DEVELOPMENT REVIEW BOARD REPORT

DC Ranch Crossing Hotel 45-DR-2017

Location: 18211 North Pima Road

**Stipulations for the
Development Review Board Application:
DC Ranch Crossing Hotel
Case Number: 45-DR-2017**

WEST ELEVATION

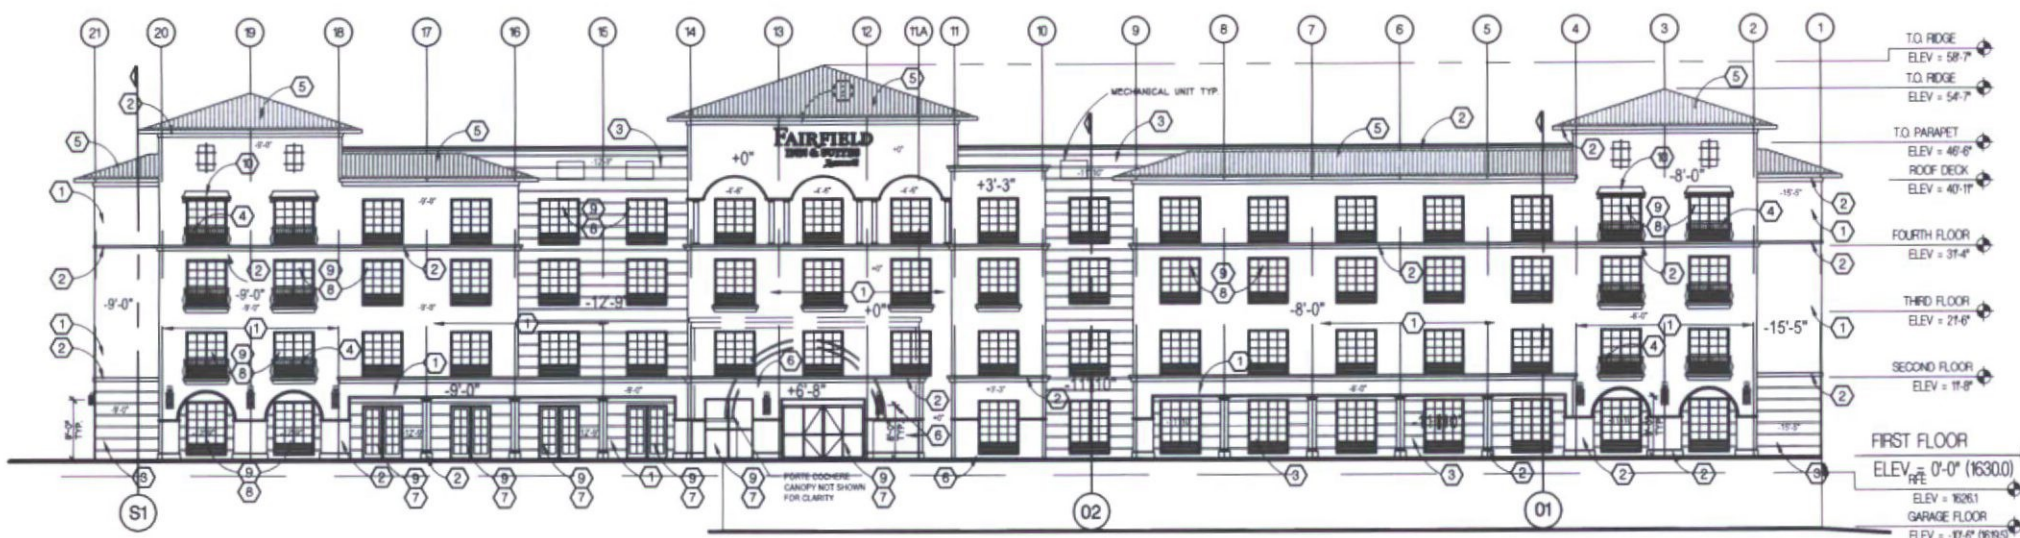
2. At time of final plans, the applicant shall revise the off-set wall planes on the north and south building elevations by incorporating additional wrought iron grilles and recessed wall areas on the

4. At time of final plans, the applicant shall revise the east building elevations by incorporating additional textured EIFS shade overhangs over each of the storefronts and windows next to the pool and pedestrian seating area.
